文件编号 Document No.	DD-202105-24	文件名称 Document Name	产品/工艺变更通知 Product/Process Change Notice(PCN)
文件版本 Document Version	中文/A1	保存期限 Retention Period	3年 3 years

主题: ESP-01D 天线引脚尺寸加长
Main Topic:

PCN 编号 PCN No.	20210524001	提出日期 Issue Date of PCN	2021-05-24
产品名称 Product Name	ESP-01D	变更日期 Proposed Date of Change	2021-06-04
封装类型 Package Type	模组 Module	首次出货日期 Proposed Date of First Shipment	2021-06-21

变更型号	变更前图片/Before change picture	变更后图片/After change picture
ESP-01D

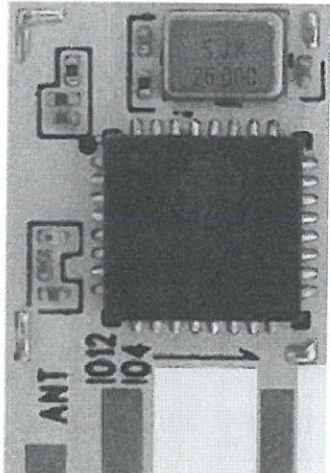
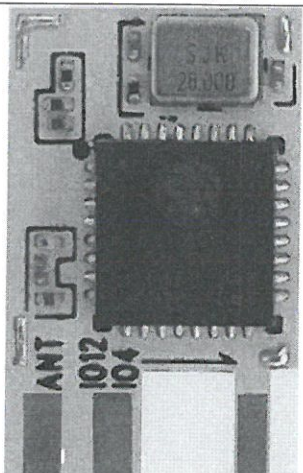
变更描述/Description of Change: 模组天线引脚焊盘长度由原来的 1mm 加长为 2.54mm

变更影响/Impact of Change:
 模组天线引脚尺寸加长, 导致露铜部分的外观有差异
